DESIGN REVIEW
RECOMMENDATION PROPOSAL

3400 Wallingford Ave N - 3014232
3326 Wallingford Ave N - 3014233

Application Date:
August 30, 2013

N Wallingford Ave. Elevation

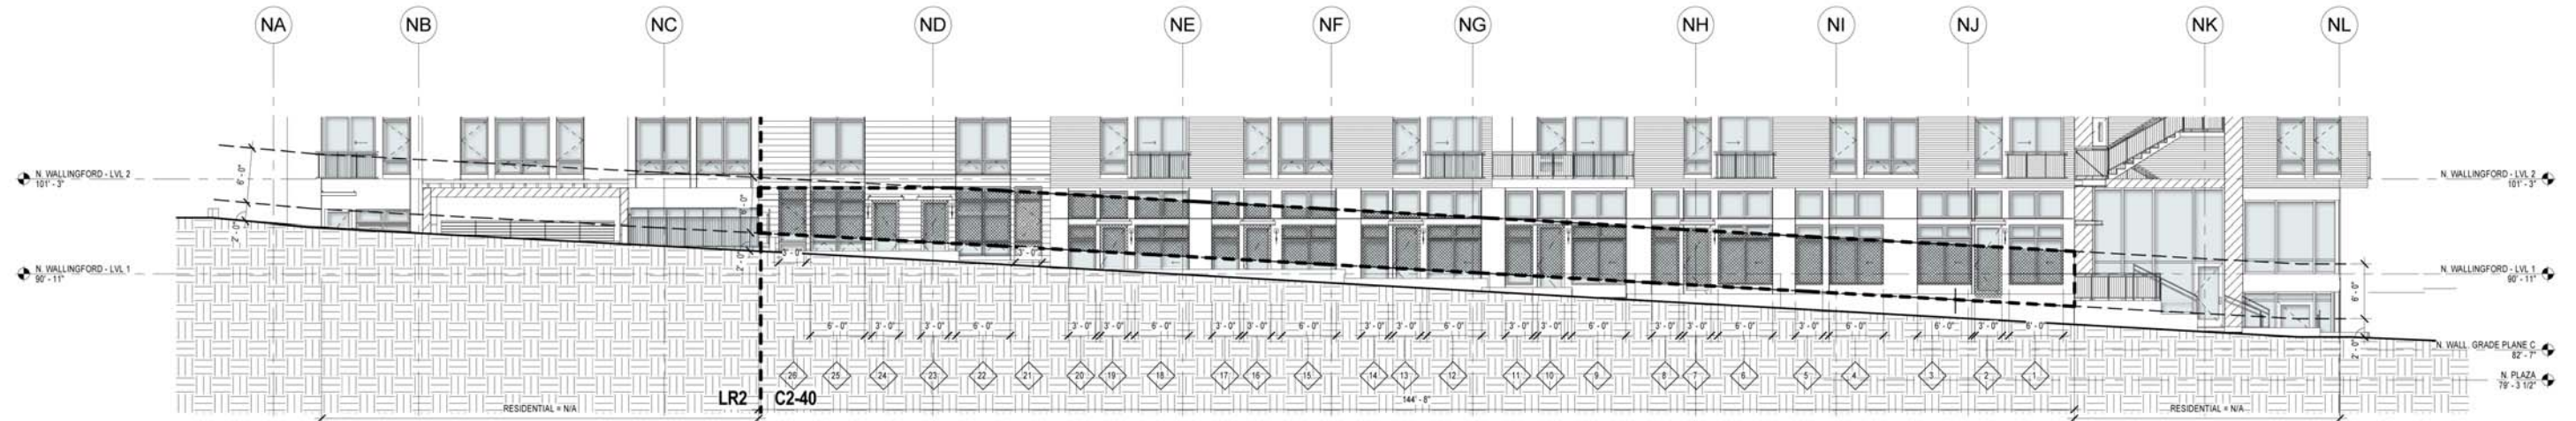
The live/work units should be treated similar to commercial storefronts .

Blank walls are minimized and corresponding transparency maximized along the length of the commercial façades. Elevations have been revised to add glazing and the departure request for blank wall has been rescinded.

See discussion of blank walls in D-2 above
The live-work units will have a significant amount of glazing to achieve the transparency goal. Elevations have been revised to add glazing and the departure request for transparency has been rescinded.

Retaining Wall Diagram

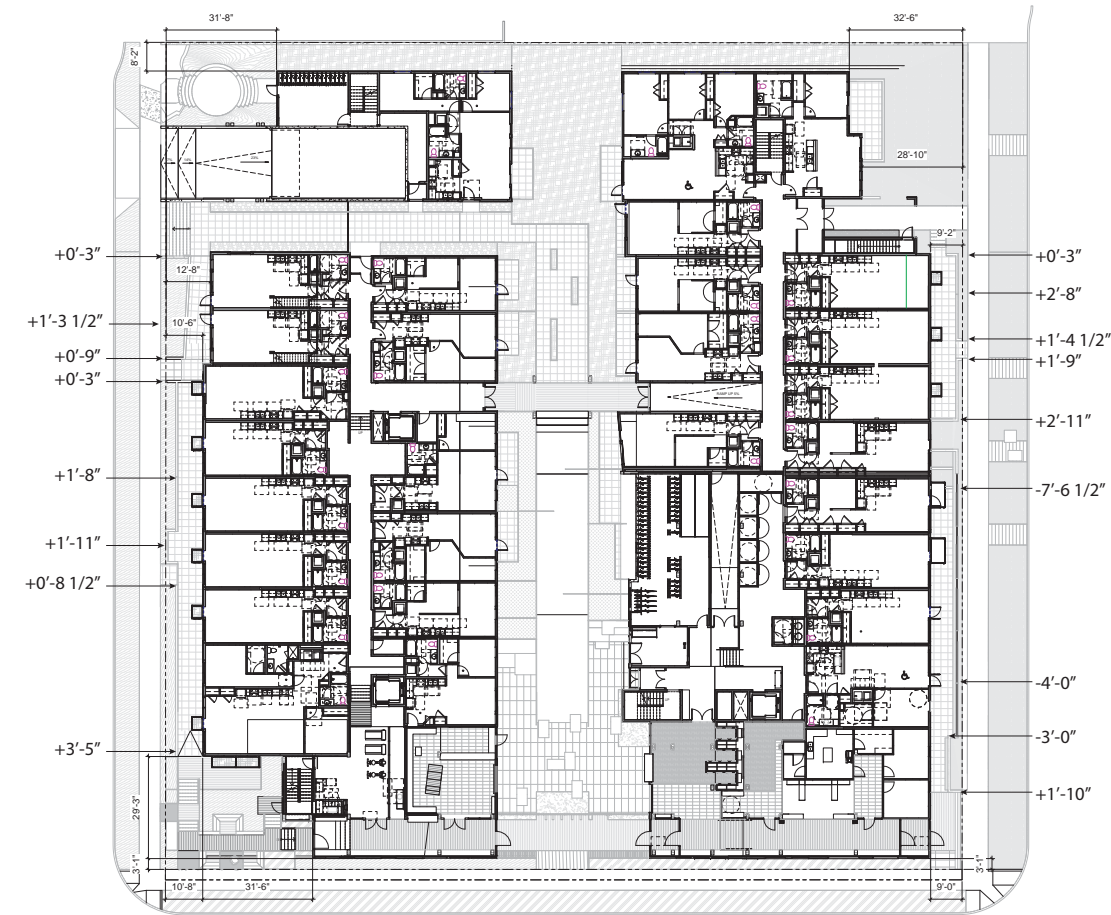
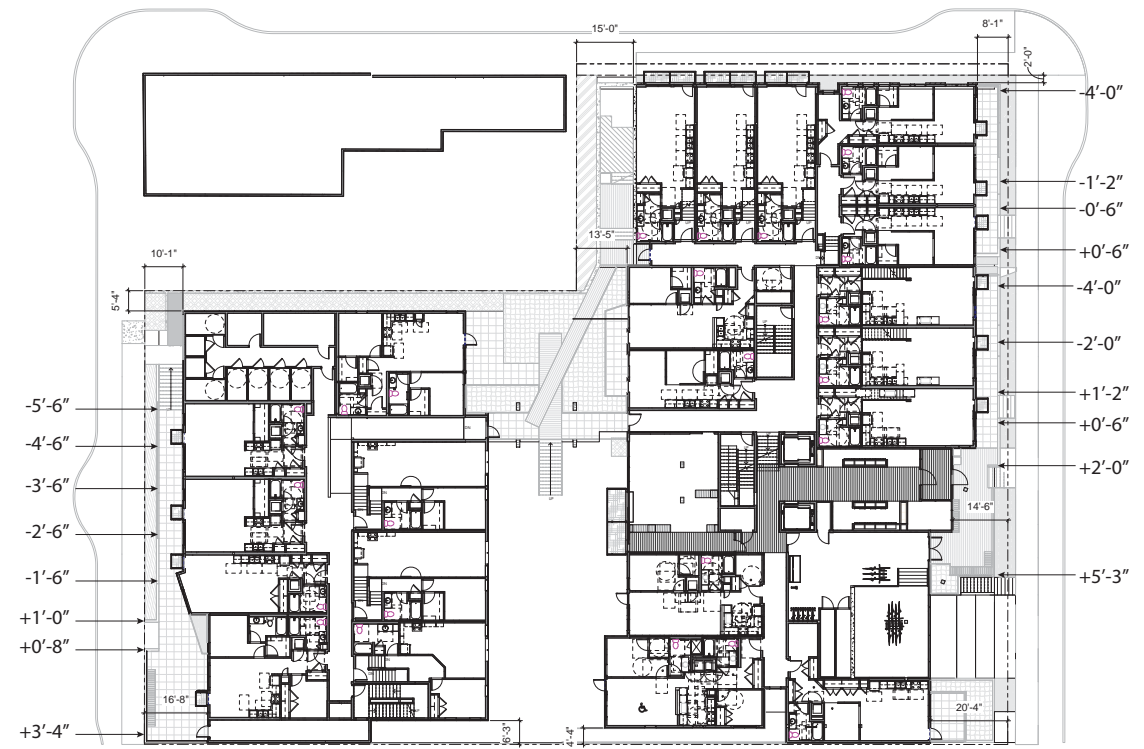
Minimize the height of retaining walls.

Where retaining walls are unavoidable, a textured surface, inlaid material and/or sensitively designed reveal lines are encouraged.

Retaining walls have been minimized. Where located they are treated with landscaping, textures or added materials.

Site Plan - South Bldg

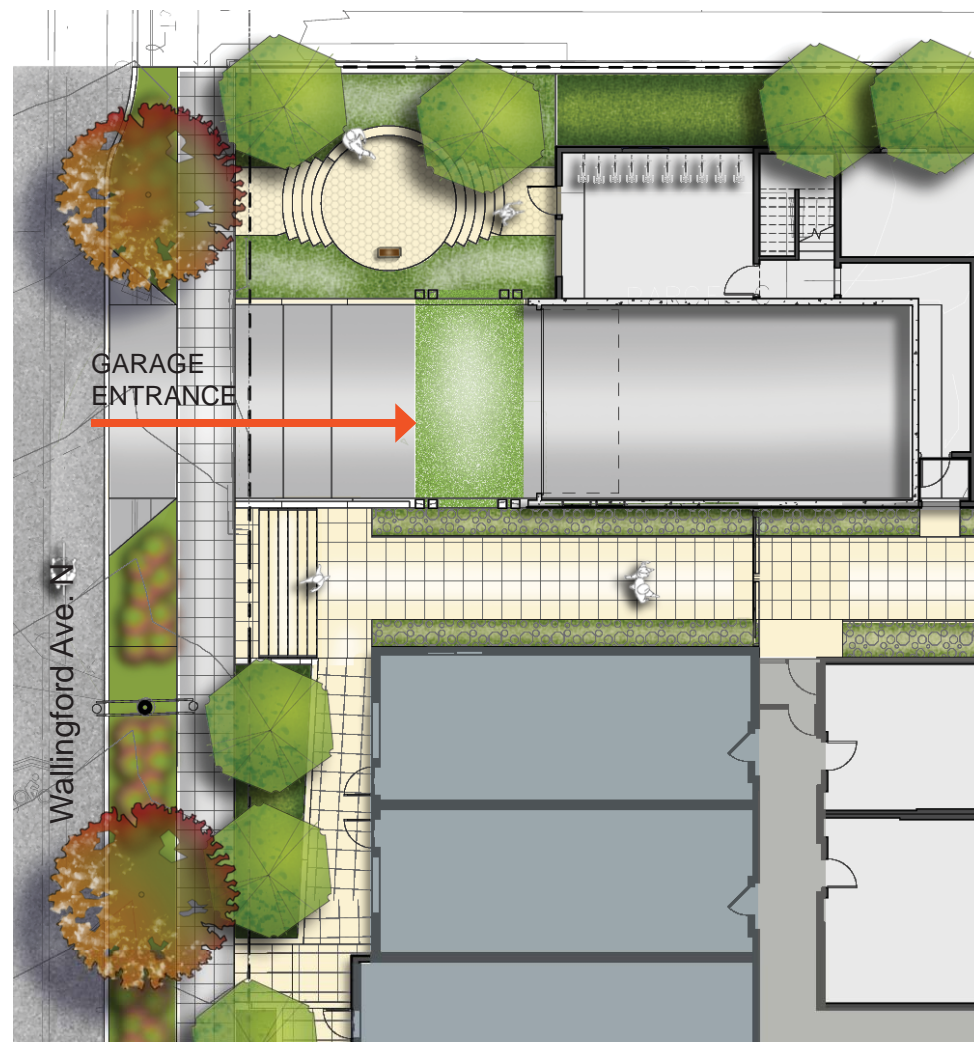
Landscape plazas and open spaces at the rights of way which provide visual permeability into the site would enhance the connection between activity at streetscape and the sequences of open space within the complex. Other than the open space at N. 34th St on the north site, the views to the interior open spaces seem narrow and closed off. If a gate is to be considered for this open space along N. 34th St. in Option # 3, the gate should be set back from the sidewalk to create an eddy as an intermediary space between the public sphere and the private realm between the units. A landscape and placemaking site strategy should impact building forms, not merely decorating the edge of the site.

The security gate at the "Boardwalk Courtyard" at the midpoint on 34th Street is recessed from the right of way to allow for public accessibility and gathering and seating areas. In addition, as shown in the DRB package perspective, this gate is mostly transparent. A metal frame allows visual access through the center of the two sites from outside in as well as from inside out. The gate utilizes elements of the wood boardwalk decking to transform vertically into low screens, benches and bike racks to provide functional security while still allowing visual transparency.
